RECORD PLANS

PROPOSED IMPROVEMENT
 BRIDGE PROJECT

PROJECT NAME: MENDON
 PROJECT NUMBER: BRO 1443(43)

STA 51+41 RT. (ABUT #1)
 BEGIN UNCLASSIFIED CHANNEL EXCAVATION
 BEGIN STONE FILL, TYPE IV
 BEGIN GEOTEXTILE UNDER STONE FILL
 BEGIN GRUBBING MATERIAL
 END GRUBBING MATERIAL 51+56 RT.

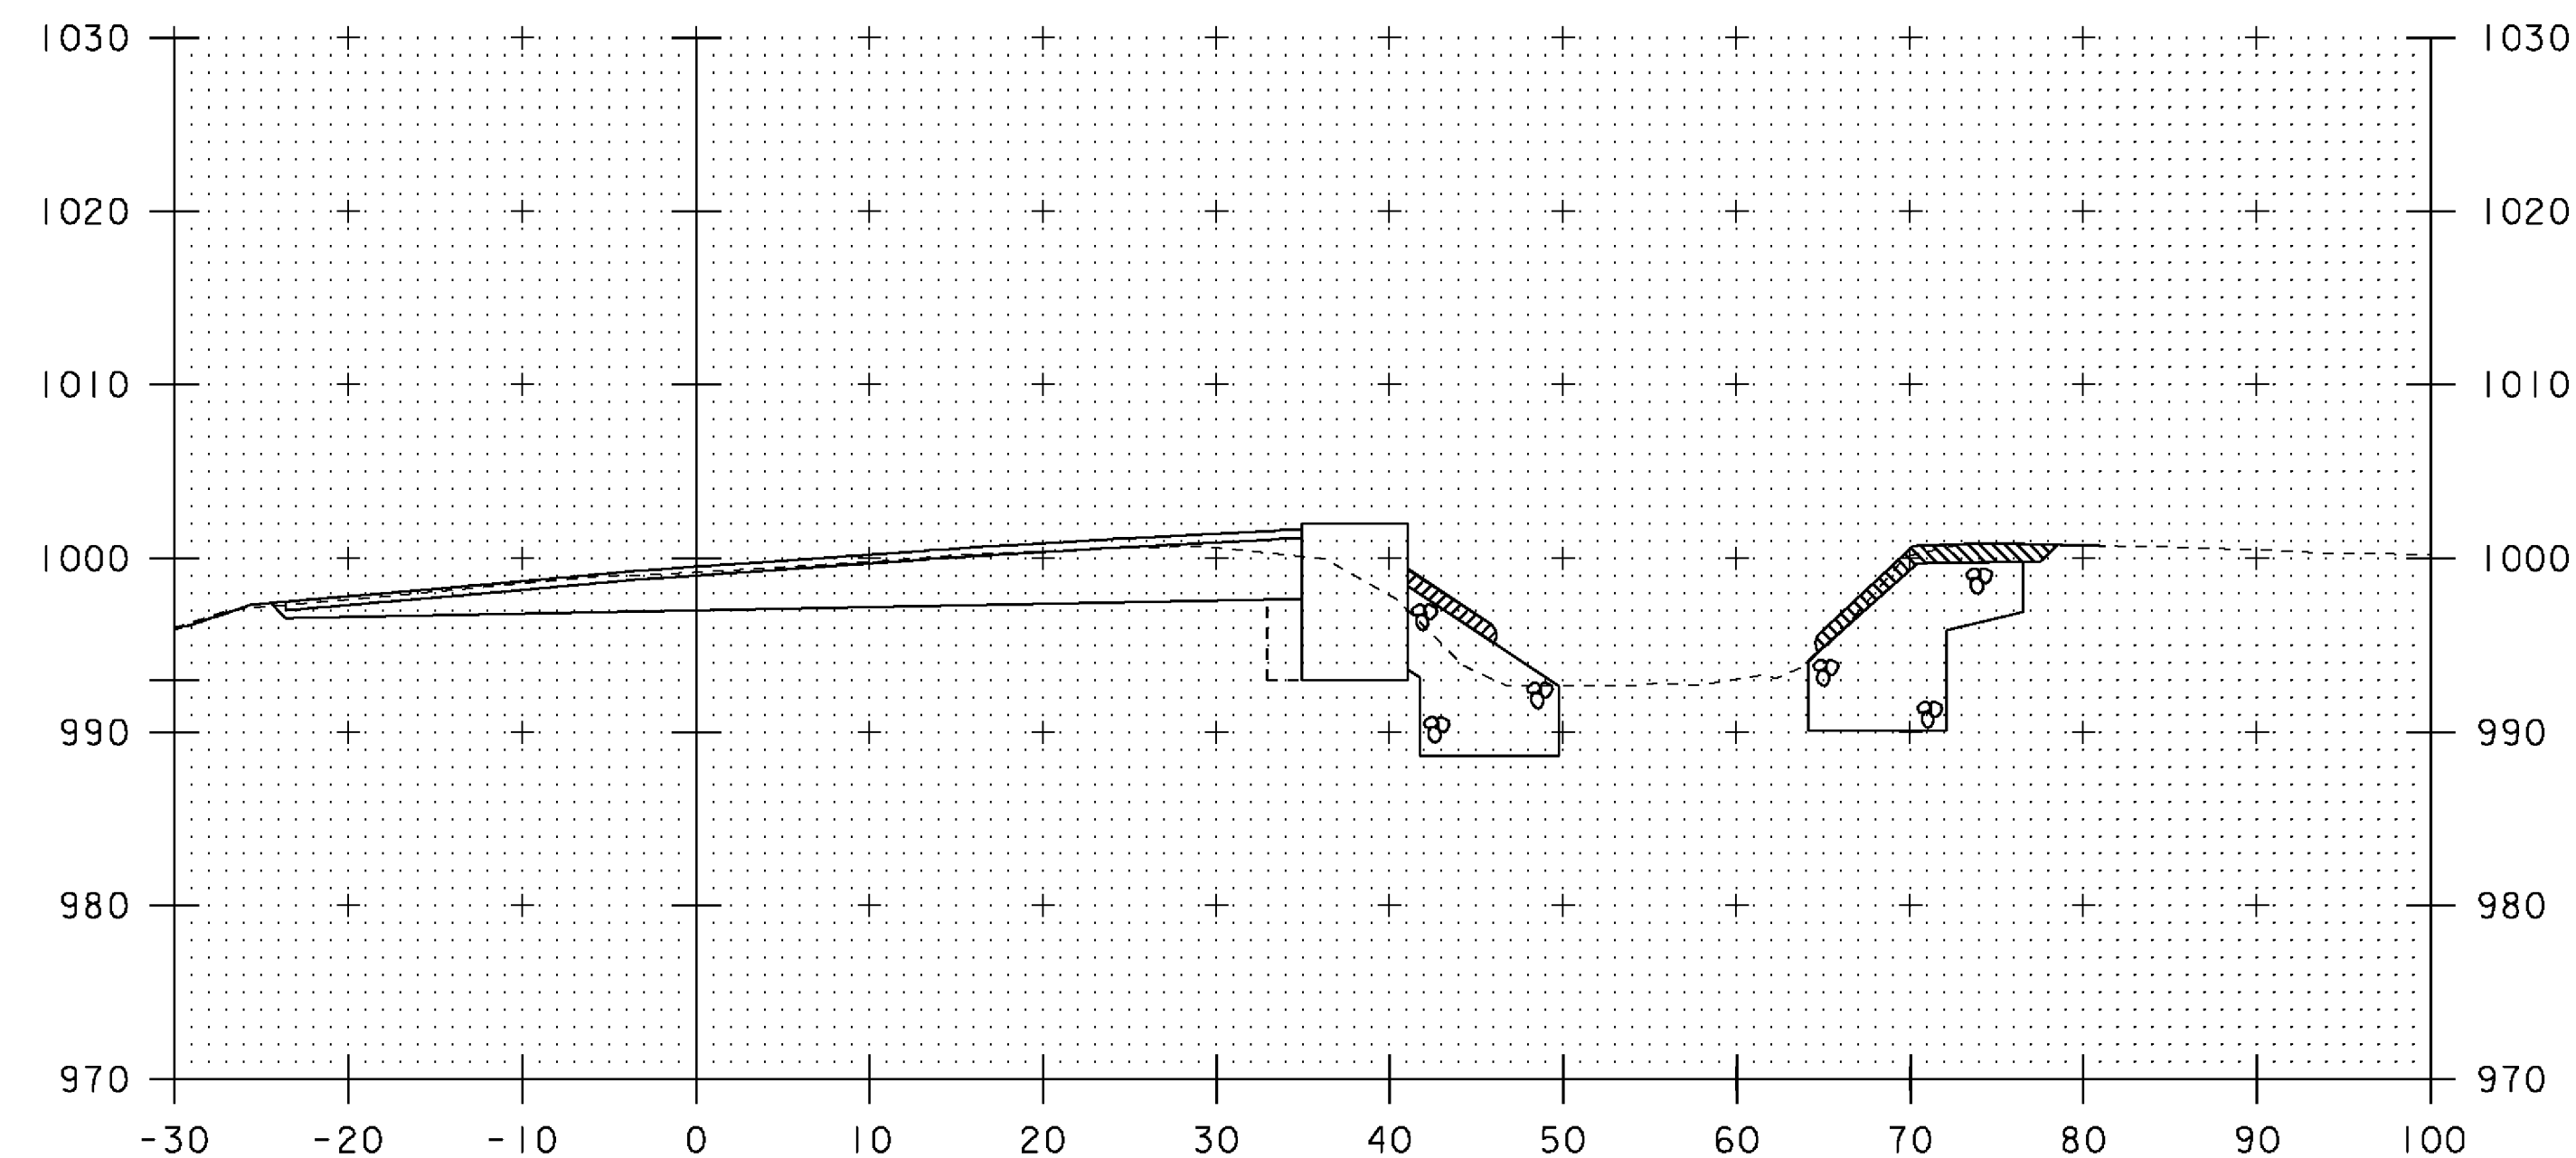
EXISTING GROUND NO LONGER VALID SINCE IRENE 8-28-11.
 NEW SURVEY REQUIRED FOR CHANNEL SECTIONS
 (TYP ALL SHEETS 31 & 32).
